UNITED STATES PATENT AND TRADEMARK OFFICE

APPLICATION NO.	FILING DATE	FIRST NAMED INVENTOR	ATTORNEY DOCKET NO.	CONFIRMATION NO.
10/590,463	08/23/2006	Mats Annerfeldt	2005P02667WOUS	9725

Office Action Summary	Application No. 10/590,463	Applicant(s) ANNERFELDT ET AL.	
	Examiner NATHANIEL WIEHE	Art Unit 3745

DETAILED ACTION

Fig. 1'

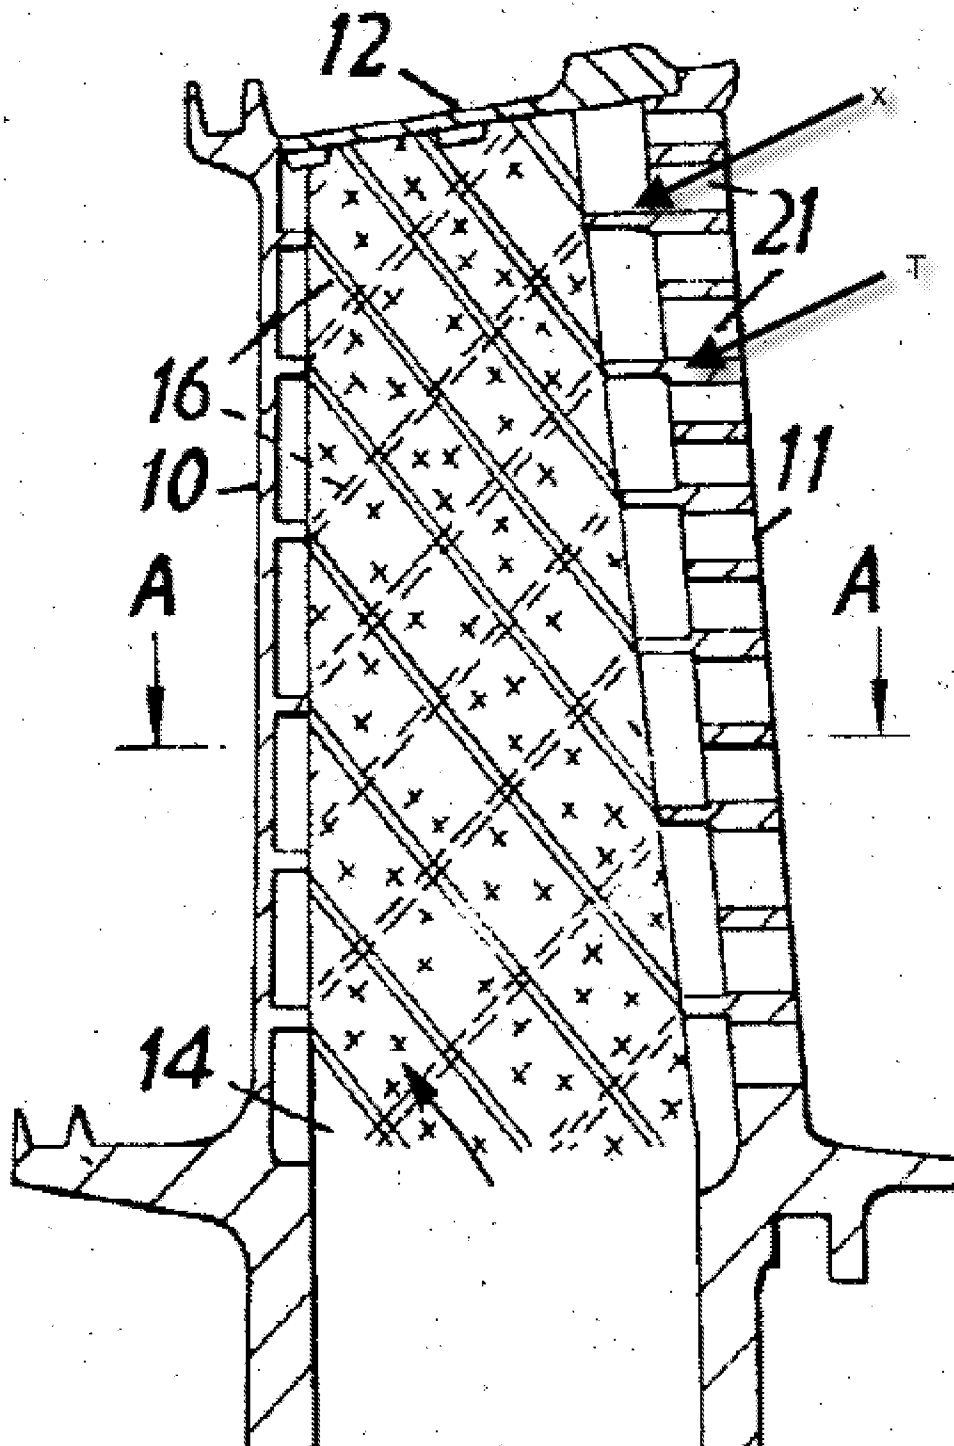
Claims 21-25 and 30-41, as far as they are definite, are rejected under 35 U.S.C. 102(b) as being anticipated by Moore (3,806,274). Moore discloses a blade for a gas turbine having an inner space is defined by a first, radially extending, pressure sidewall (17) and a second, radially extending, suction sidewall (18), an inlet area (13) arranged radially inward of the sidewalls, a top area opposite the inlet area (13) and at a radially outer end (12) of the first and second walls and an outlet area arranged toward the trailing edge (11) of the blade forming a passage for cooling fluid to flow from the inlet area to the outlet area. Moore includes a plurality of helical ribs (16) that extend from both the first wall (17) and the second wall (18) each substantially parallel along the respective walls and extending from the leading edge constituting the claimed plurality of first ribs and plurality of second ribs respectively. Further, the ribs (16) from each wall join at a singular point near the trailing edge that is coincident with the trailing edge passage ribs (X) that further include thickened portions (T) constituting reduced

flow area trailing edge outlet channels (21) (See Fig. 1' below). Since the trailing edge ribs (X) are formed at the juncture of the first and second sidewall ribs (16) they are construed as the portions of said first and second ribs in the "proximity of the trailing end". Also, these trailing edge ribs (X) form a common outlet channel for the first and second channels. The first side (17) ribs, in shadow in Fig. 1, extend along a first direction in proximity to the leading end that forms a first angle of inclination with respect to the rotary axis of the rotor. The second side (18) ribs, in solid lines in Fig. 1, extend along a third direction in proximity to the leading end forming a third angle of inclination with respect to the rotary axis of the rotor. The portions of the first and second ribs in proximity of the trailing end, i.e. those portions constituted by trailing edge ribs (X), extend in a second and fourth direction, respectively, that is inclined in relation to both the first and third directions, are equal to one another and are substantially parallel to the rotary axis. The first and third directions intersect each other and the third direction slopes from the leading end toward the rotary axis while the first direction slopes from the leading end away from the rotary axis. The ribs (16,X) extend over a leading zone and a trailing zone.
